Important Notices

TOSHIBA Microcontrollers 900 Family
(TMP91CW12F) (TMP91PW12F) (TMP91CW12AF) (TMP91FY12AF) (TMP91C815F) (TMP91C016F)
(TMP91CW18AF) (TMP91PW18AF) (TMP91C219F) (TMP91C820AF) (TMP91CY22F)
(TMP91FY22F) (TMP91C824F) (TMP91C025F) (TMP91CK27U) (TMP91CP27U)
(TMP91CP27RUG) (TMP91CU27U) (TMP91CU27RUG) (TMP91FY27U) (TMP91CW28FG)
(TMP91CY28FG) (TMP91FY28FG) (TMP91C829F) (TMP91C630F)
(TMP92C820FG) (TMP92CH21FG) (TMP92CM22FG) (TMP92CA25FG) (TMP92CM27FG)
(TMP92CD54IF) (TMP92FD54AIF)
(TMP94C241CF) (TMP94C251AF)

Restriction on Use of 8-bit Timers

Datasheet Modifications: Interrupt controller

Example when using PWM mode

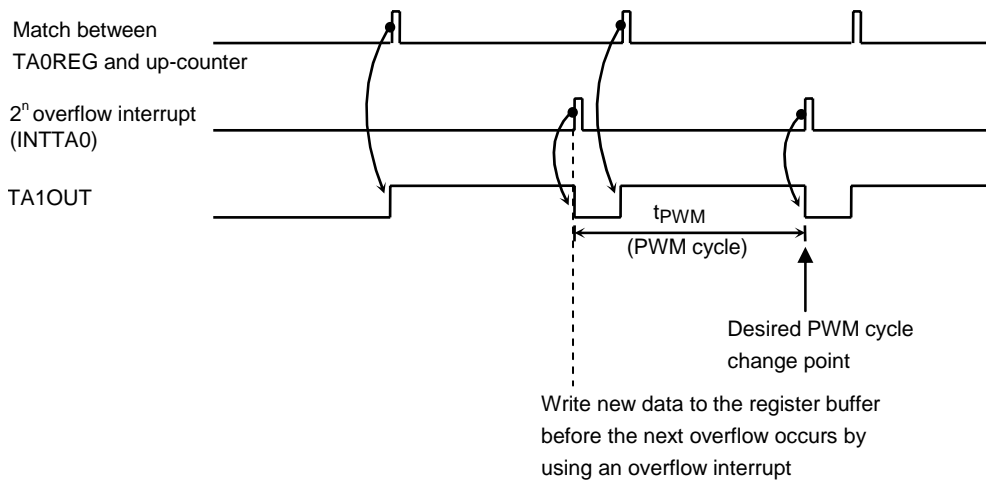
When the double buffer is enabled for an 8-bit timer in PWM or PPG mode, caution is required as explained below.

If new data is written to the register buffer immediately before an overflow occurs by a match between the timer register value and the up-counter value, the timer flip-flop may output an unexpected value.

For this reason, make sure that in PWM mode new data is written to the register buffer by six cycles ($f_{sys} \times 6$) before the next overflow occurs by using an overflow interrupt.

In the case of using PPG mode, make sure that new data is written to the register buffer by six cycles before the next cycle compare match occurs by using a cycle compare match interrupt.
